Service Bulletin No: 57-015
Modification No: INSPECTION

**WING - AILERON INSTALLATION
INSPECTION OF THE AILERON OUTBOARD-BEARING SUPPORT**

Inspection of the Attachment Bolts and Anchor Nuts
Figure 1

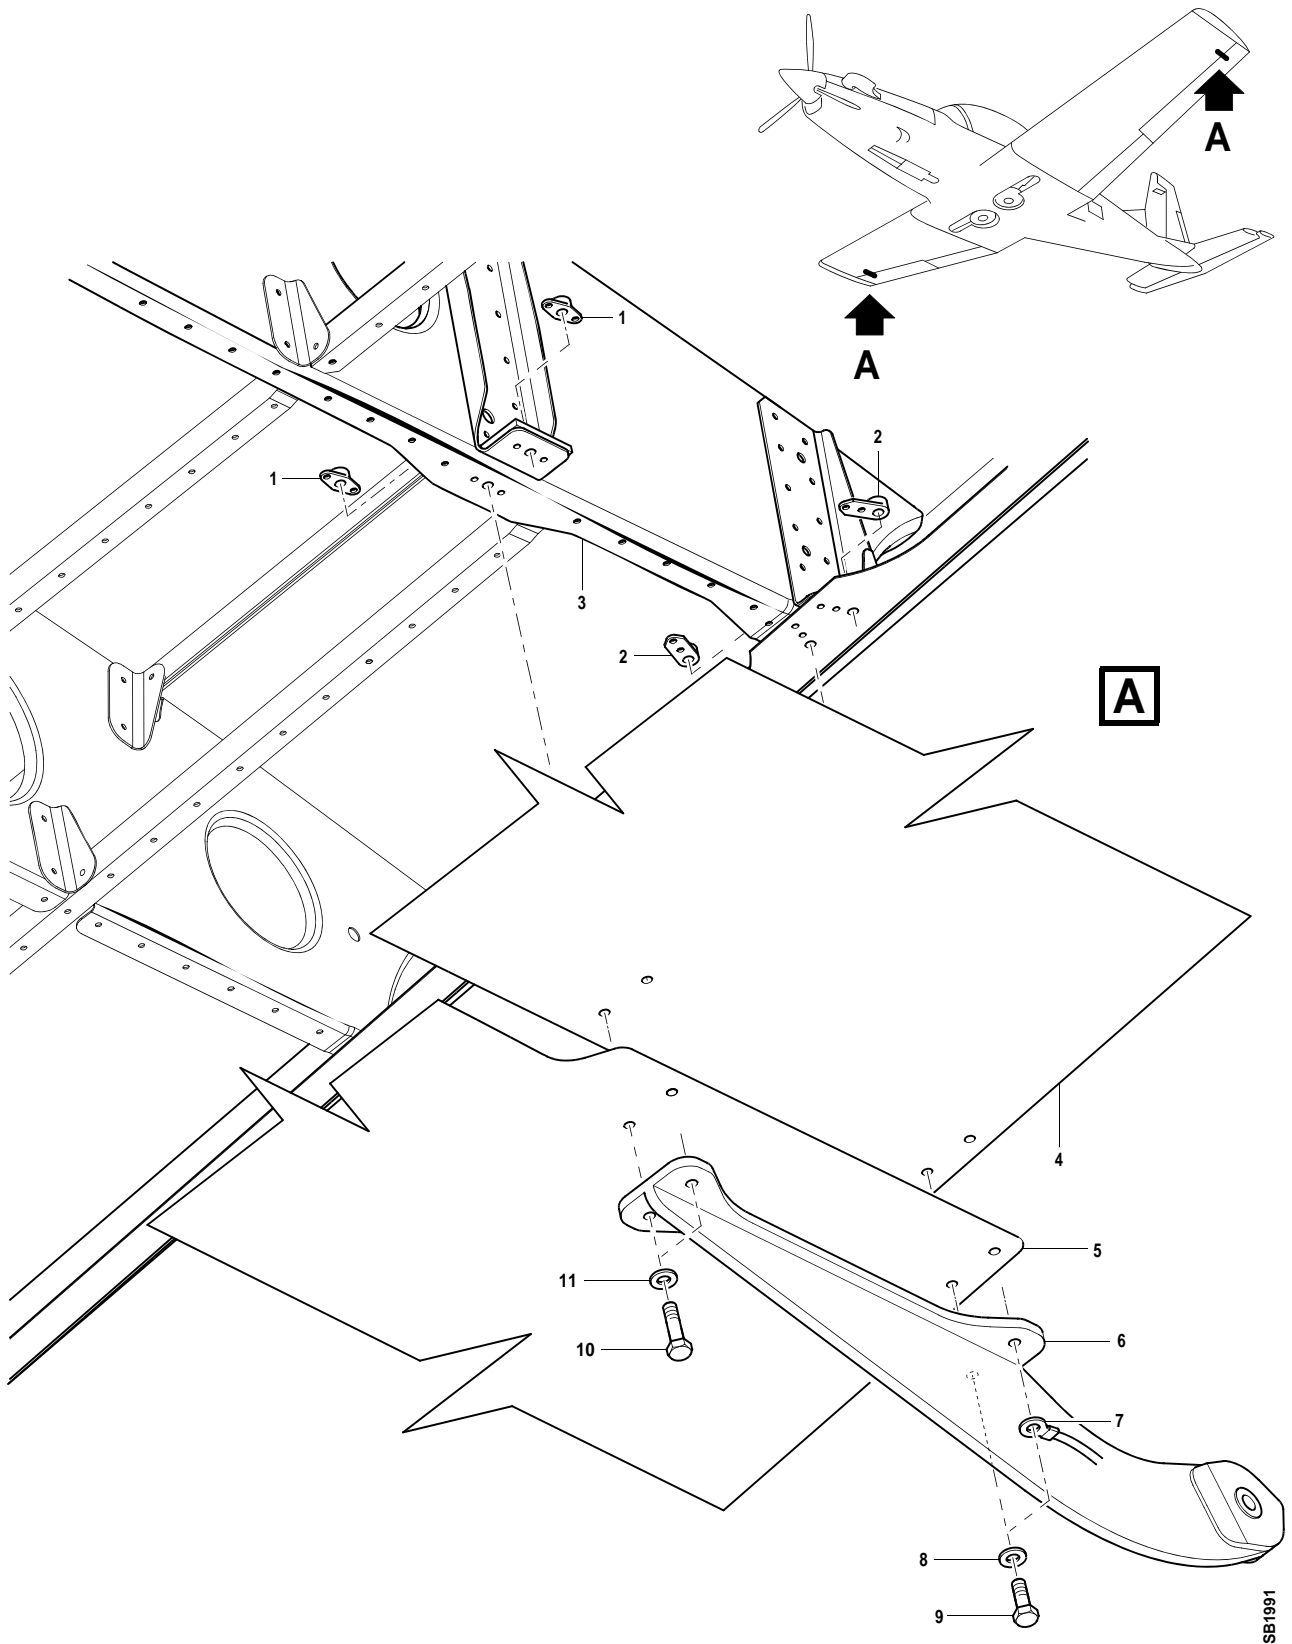
The aileron outboard-bearing supports are attached with two forward attachment bolts and two aft attachment bolts. The forward attachment bolts are approximately 3.2 mm (0.125 in.) longer than the aft attachment bolts.

In the case of the reported incident, the longer bolts were installed in the rear attachment points. This, most probably, damaged the threads in the rear attachment anchor nuts. If the bolts are removed and installed again and again, this can also cause damage to the threads of the nuts.

WARNING: IF A BOLT (2 OR 3) IS **NOT** THE CORRECT LENGTH AND/OR THE THREAD OF THE ANCHOR NUT IS **NOT** IN A GOOD CONDITION, ALL THE ATTACHMENT BOLTS AND ANCHOR NUTS MUST BE REPLACED (REF. PARA. 3.C. OF THIS SERVICE BULLETIN) BEFORE THE NEXT FLIGHT.

- (a) Remove the bolt (3) and the washer (4) from the forward inboard attachment point of the aileron outboard-bearing support (1).
- (b) Clean the bolt (3) with the absorbent paper (Material No. P02-031) made moist with the solvent (Material No. P01-010).
- (c) Measure the length of the bolt (3). If the bolt (3) is installed in the correct position, the length will be 23,02 mm (0.906 in.) (Ref Detail on Fig. 1).

- (m) If no damage is found to the two bolts (3), do Para. 3.B.(1)(a) thru (k) again for the aft attachment bolts (2) of the aileron outboard-bearing support (1).
NOTE: If the bolt (2) is installed in the correct position, the length of the bolt will be 19,84 mm (0.781 in.) (Ref Detail on Fig. 1).

Revision No. 1 is issued to change the title of Para. 2.C and to add a requirement that if no “run-down torque” is felt, the repair procedure is to be done.

- Confirm that, during accomplishment of this Service Bulletin, normal self locking resistance was felt when the bolts (Ref. Fig. 1, items 2 and 3) were installed.
- Do Para. 3.B.(1)(k) again for the bolts (Ref. Fig. 1, items 2 and 3). Only remove one bolt at a time.

Repair - Replacement of the Attachment Bolts and Anchor Nuts
Figure 2

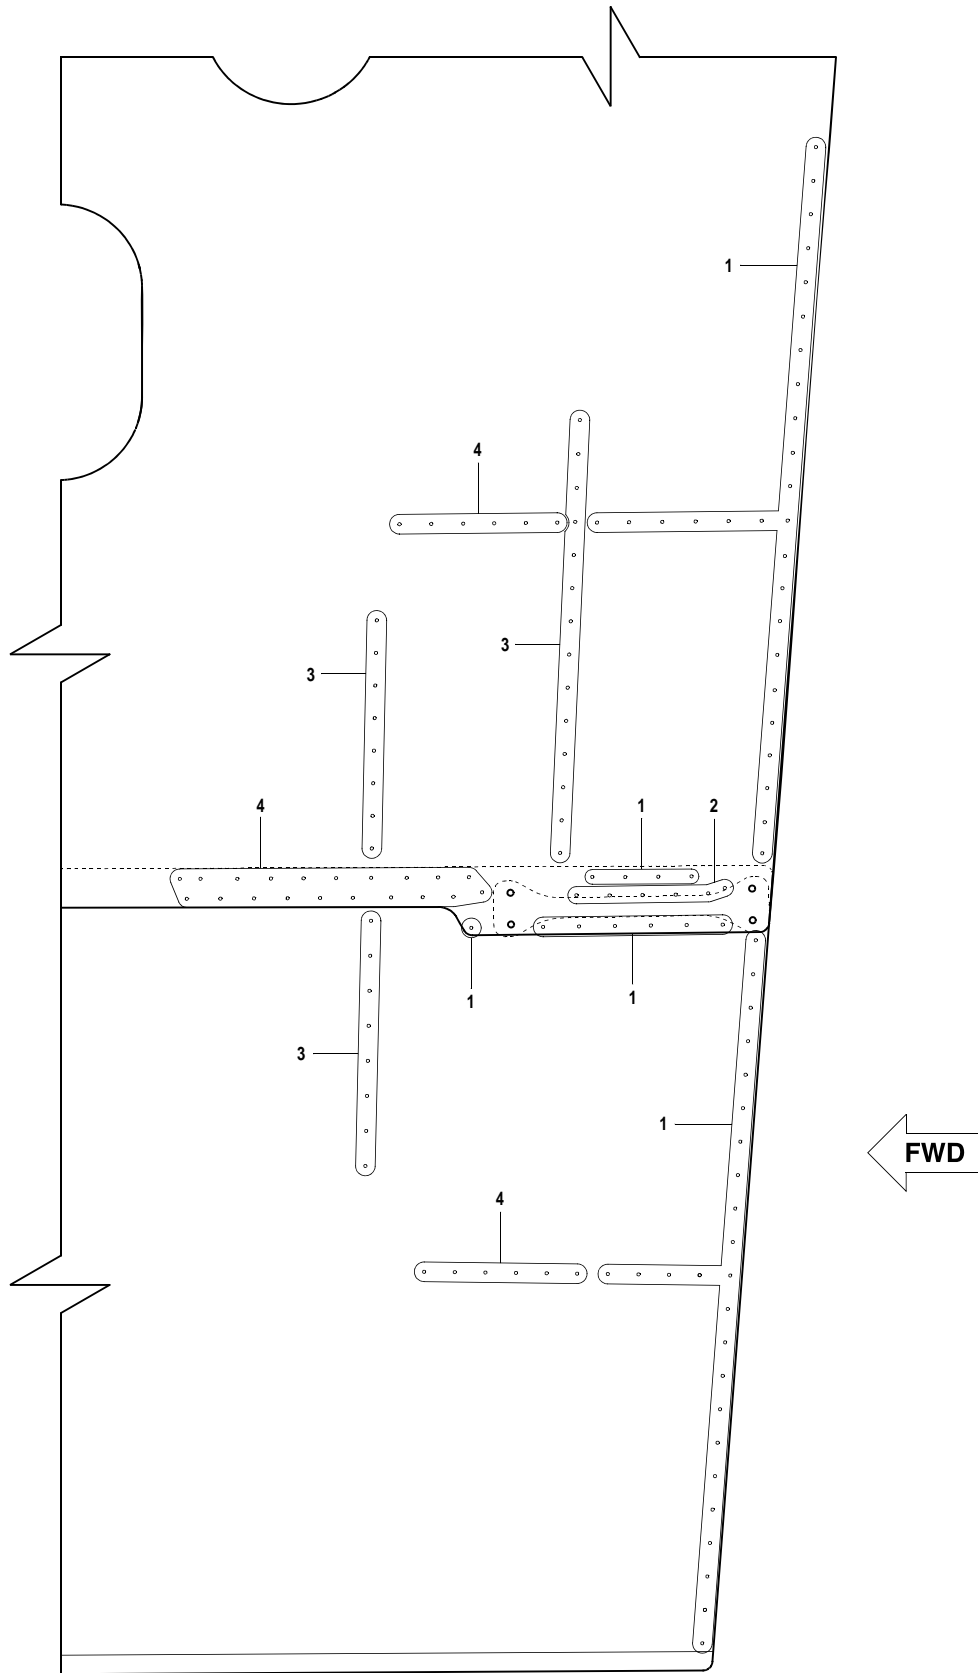
- 1 Remove the bolts (9), the washers (8) and, if necessary, the bonding strap (7).
- 2 Discard the bolts (9) and the washers (8).
- 3 Remove and discard the bolts (10) and the washers (11).
- 4 Remove the aileron outboard-bearing support (6) and the aileron trim shims (if installed).

- (b) Use the applicable diameter drill and remove the rivets (Ref. Table 1 and Ref. Fig. 3) (Ref. SRM, 51-00-04) from the wing lower-outer skin (4) to get access to the outer anchor nuts (1 and 2) installed on Rib 23 (3).
- (c) Use the applicable diameter drill and remove the rivets (Ref. Table 1 and Ref. Fig. 3) (Ref. SRM, 51-00-04) from the wing lower-inner skin, (5) to get access to inner anchor nuts (1 and 2) installed adjacent to Rib 23 (3).
- (d) Clean the work area with absorbent paper (Material No. P02-031) made moist with the solvent (Material No. P01-010).

- (a) Use the applicable diameter drill (Ref. SRM, 51-00-04) and remove and discard the anchor nuts (1 and 2).
- (b) Put the wing lower-outer skin (4) and the wing lower-inner skin (5) in position.
- (c) Use gripper pins (or equivalent) to hold the wing lower-outer skin (4) and the wing lower-inner skin (5) in position.
- (d) Put the aileron outboard-bearing support (6) and aileron trim shims (if installed) in position on the wing.

- (f) Ream the attachment holes of the forward and aft aileron outboard-bearing support with the 4,9 mm (tolerance: - 0,0 + 0,012 mm) reamer.

- (g) Ream the FWD aileron outboard-bearing support attachment holes with the 5,0 mm (tolerance: - 0,0 + 0,012 mm) reamer.

- (i) Ream the attachment holes (in the aircraft structure only) of the AFT aileron outboard-bearing support with the 5,0 mm (tolerance: - 0,0 + 0,012 mm) reamer.

- (n) Install the anchor nuts (1 and 2) with the rivets (MS20426AD3) (Ref. SRM, 51-00-04).
